Access Compliance Report

Public Rights-of-Way

(Curb Ramps)

Intersection ID: 12013	Main Street: FREEDOM_DR	Cross Street: W_MOREHEAD_ST	Location:	E
ADA ID: 540AFF9A5890	Ramp Type: Perp	Initial Pass/Fail: Fail	Overall Compliance: No	Severity Score: 12.5
Codes/Mitigation Info/Possible Solution		Field Measurements/Component Compliance

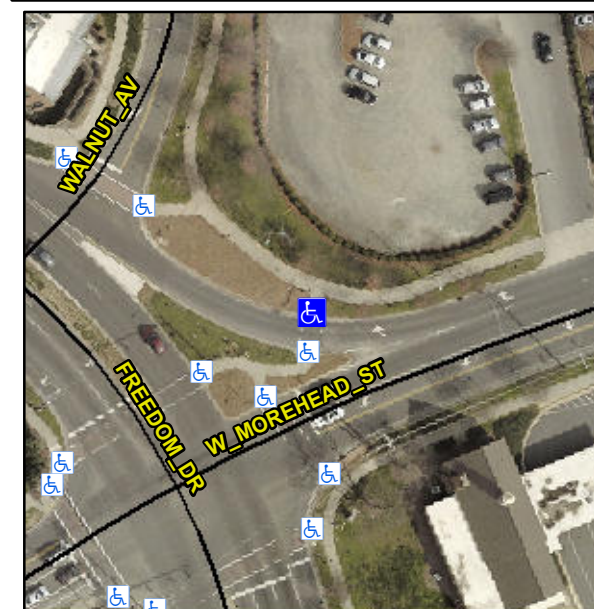
Not Found, R304.2.2

Compliance	Description	Data	Compliance	Description	Data
N/A	Ramp Length (in)	62.5	No	Ramp Slope (%)	10.3
Yes	Ramp Width (in)	48.0	Yes	Ramp XSlope (%)	0.8
N/A	Flare Type LT	N/A	N/A	Flare Type RT	N/A
N/A	Flare Slope LT (%)	N/A	N/A	Flare Slope RT (%)	N/A
N/A	Flare Traversable LT?	N/A	N/A	Flare Traversable RT?	N/A
N/A	Landing Length (in)	N/A	N/A	DWS Provided?	N/A
N/A	Landing Width (in)	N/A	N/A	DWS Contrast?	N/A
N/A	Landing Slope (%)	N/A	N/A	DWS Length (in)	N/A
N/A	Landing X Slope (%)	N/A	N/A	DWS Full Width?	N/A
N/A	Landing Curb? (Y/N)	N/A	N/A	DWS Offset (in)	N/A
N/A	Shared Landing?	N/A			
N/A	Gutter Ponding?	N/A	N/A	Gutter Slope (%)	N/A
N/A	Gutter Lip Ht (in)	N/A	N/A	Gutter X Slope (%)	N/A
N/A	Painted X Walk1?	Yes	N/A	Painted X Walk2?	N/A
	X Walk 1 Direction	To S		X Walk 2 Direction	N/A
N/A	X Walk 1 Width (in)	110.0	N/A	X Walk 2 Width (in)	N/A
	X Walk 1 Slope (%)	1.8		X Walk 2 Slope (%)	N/A
	X Walk 1 X Slope (%)	0.8		X Walk 2 X Slope (%)	N/A

Remove & Replace Entire Ramp.
